UNITED STATES PATENT AND TRADEMARK OFFICE

10/815,685

Office Action Summary

【図2】

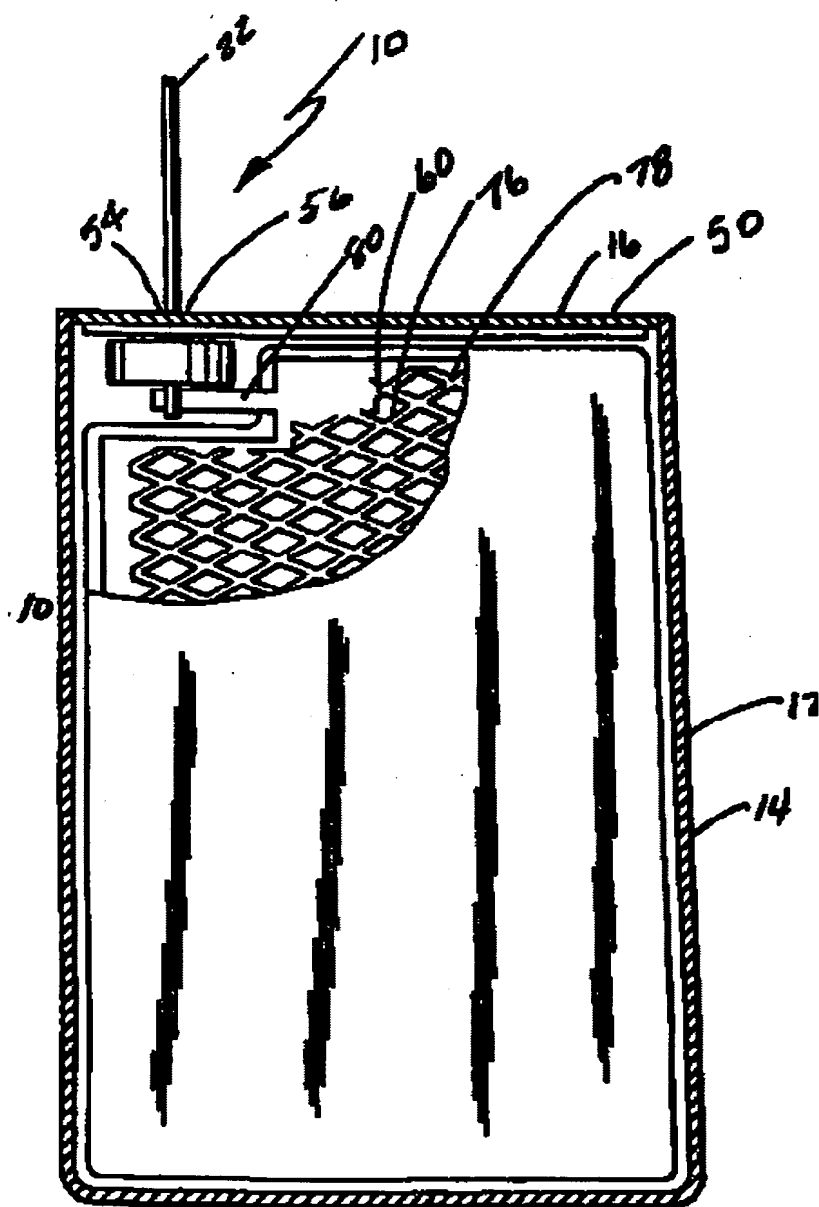
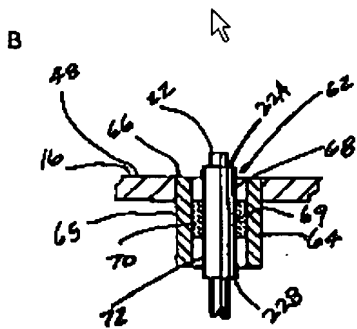
5. Claims 1-4 are rejected under 35 U.S.C. 102(b) as being anticipated by JP A 2002-373641 (JP '641).

JP '641 discloses a system for electric coupling of a plane connection 80 on a current output terminal comprising a tubular conducting slug 22, wherein said connection 80 comprises a hole and in that said connection is fixed on a transversal section of said slug 22 in such a manner as to cause this hole to electrically communicate with the inside of said tube (Figs. 2 applied to claims 1 and 3). The

connection is welded to said slug (applied to claim 2). In one embodiment, the slug is provided with an outer sleeve 69 and inner separate portion 22 (see Figs. 3, 4 and 6) wherein the extended portion 22 would be the part in electrical communication with the lead from the electrochemical cell. Thus in employing the sleeved terminal in the lower figure into the battery of Fig. 2, the inner portion 22 would be the portion which would communicate with the opening in the lead 80 (as applied to claims 1 and 3). The arrangement in the lower figure includes a surrounding annular glass seal 69 (as applied to claim 4).

【☒ 1】

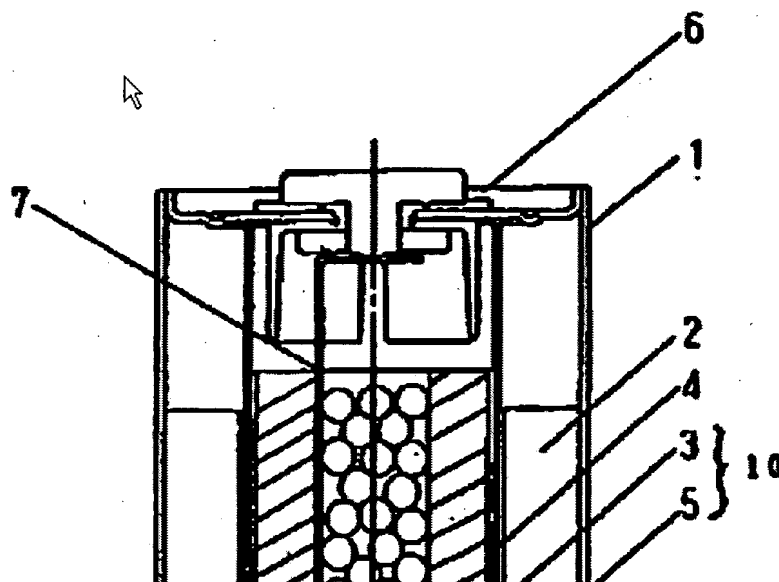
6. Claims 1 and 2 are rejected under 35 U.S.C. 102(b) as being anticipated by JP 09-153368 A (JP '368).

JP '368 discloses a system for electric coupling of a plane connection 7 on a current output terminal comprising a tubular conducting slug, wherein said connection 7 comprises a hole and in that said connection is fixed on a transversal section of said slug in such a manner as to cause this hole to communicate with the inside of said tube (Fig. 1 below applied to claim 1). The connection 7 is welded to said slug (as applied to claim 2).
